IN THE MATTER of **Private Plan Change 59** – Albany Precinct 10 to the Auckland Unitary Plan

HEARING DIRECTION #2 FROM THE HEARING PANEL

**MEMORANDUM OF COUNSEL ON BEHALF OF BEI GROUP LIMITED
– RESPONSE TO HEARING PANEL DIRECTION #1**

Figure I552.6.45.1 Building coverage and setback at upper levels

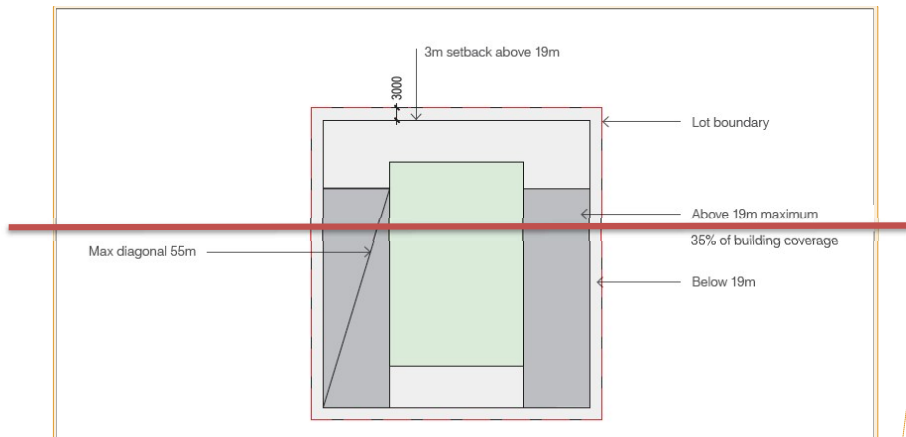
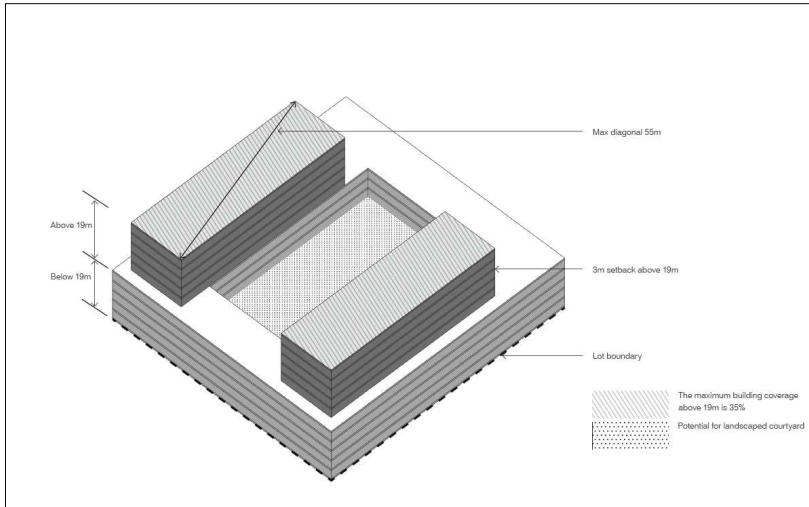
Commented [AC79]: 73.51 – Opposed in part to 6m upper-level setback.

Commented [AC80]: 73.51 – Figure deleted. Amended figure without colour and explanatory graphic in 3D included for interpretative ease.

Amended figure without colour and explanatory graphic in 3D included for interpretative ease.

Precinct Plan 2

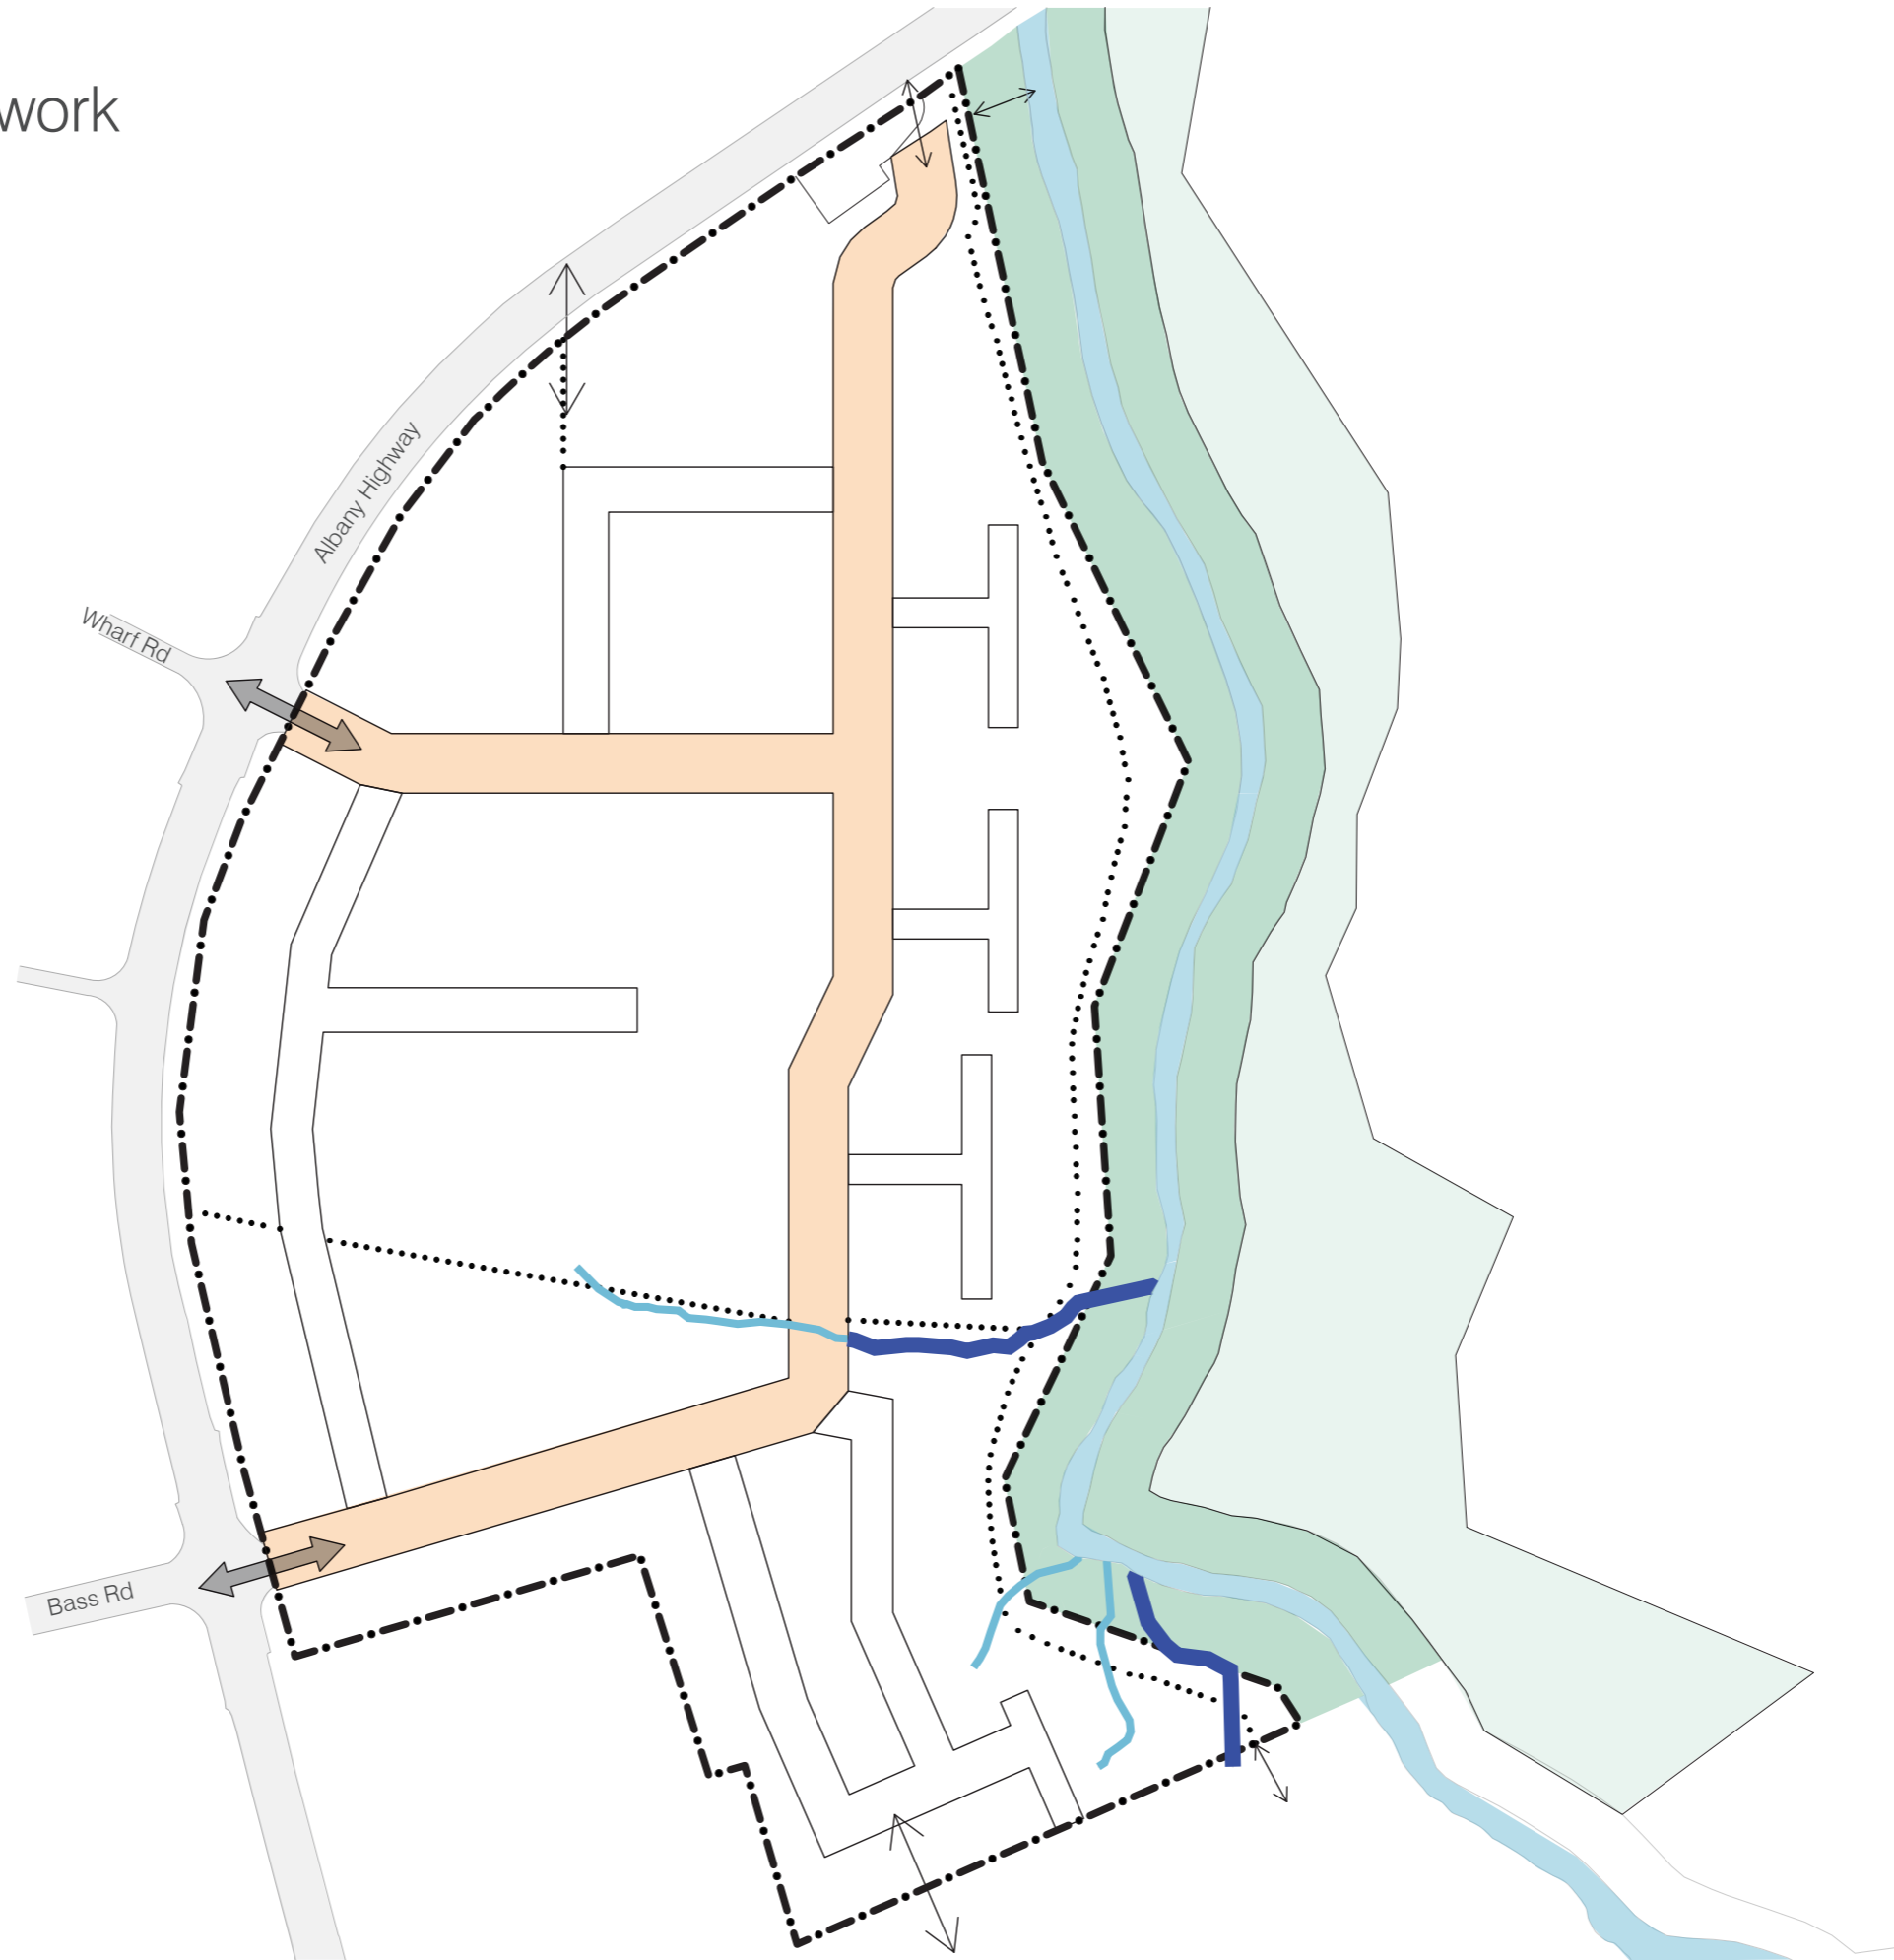
Commented [AT126]: 127.40 – Supported. Requested deletion of the northern vehicle access with amended precinct plans. Now provides for pedestrian/cycle connection only.
